寄件者: Thomas Wan <[REDACTED]>
寄件日期: 2026年09月15日星期二 9:01
收件者: Adrian Tsz Hin TAM/PLAND
副本: Kit Lo; William Shu Tai WONG/PLAND; Johnny Chung Yin LAM/PLAND
主旨: RE: Planning Application No. A/NE-MUP/236
附件: Lots 188(Part) and 189RP, Demarcation District No.38 (V1).pdf

Lots 188(Part) and 189RP,
Demarcation District No. 38

Remark:
 CHEUK YU CONSTRUCTION COMPANY LIMITED Tel: 9182 5352
Application Location: Lots 188(Part) and 189RP, Demarcation District No. 38
Scale: 1 : 500 (A3)
Date: 08/09/2026
Drawing Title: 11m Swept Path 2
Drawing No: Proposed Location Plan & Legend

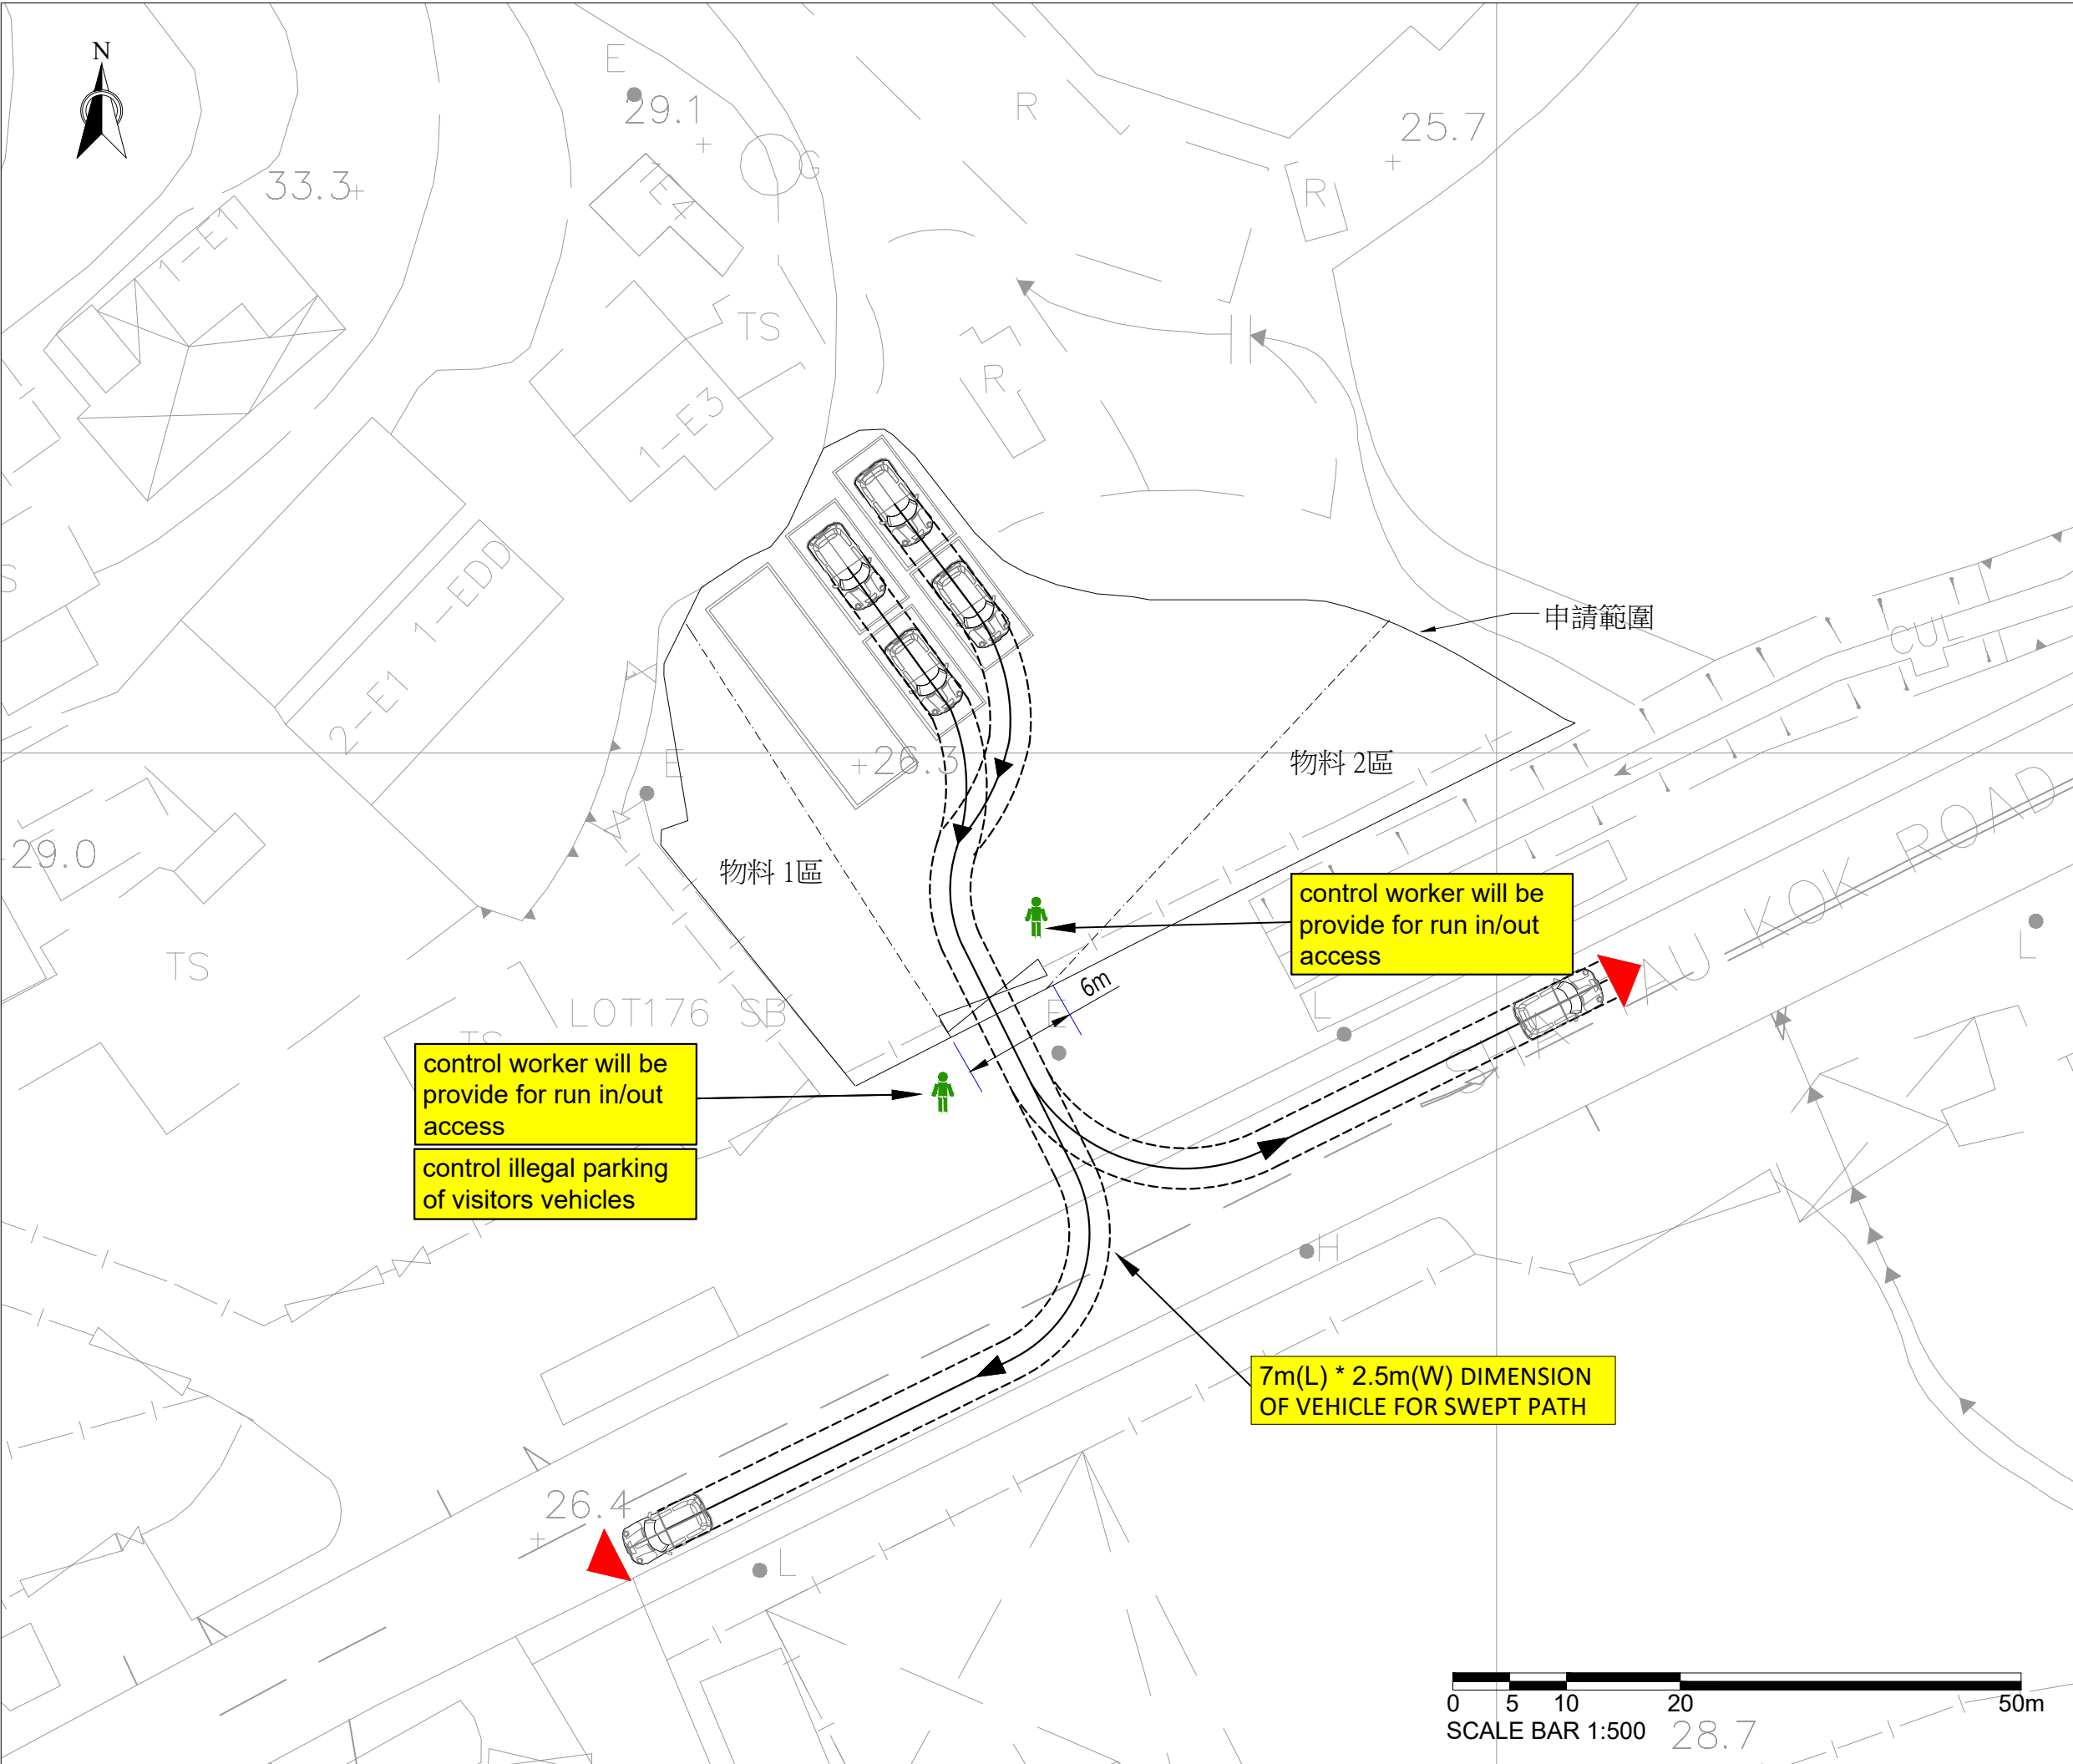
1. Swept path analysis should demonstrate that HGV would not encroach onto the opposite lane when entering/leaving Sha Tau Kok Road to/from the application site; and
2. According to your swept path analyses for HGV entering and leaving the application site, the run-in/out will be over 30m width. Excessive width of the ingress/egress point is normally not recommended; and
3. It is noted 12.8m (L) vehicle is used for swept path analysis, which is inconsistent with your proposed HGV parking space dimension (11m x 3.5m). You should clarify whether a vehicle of this dimension will be used in your operation.

DWG updated, please check.
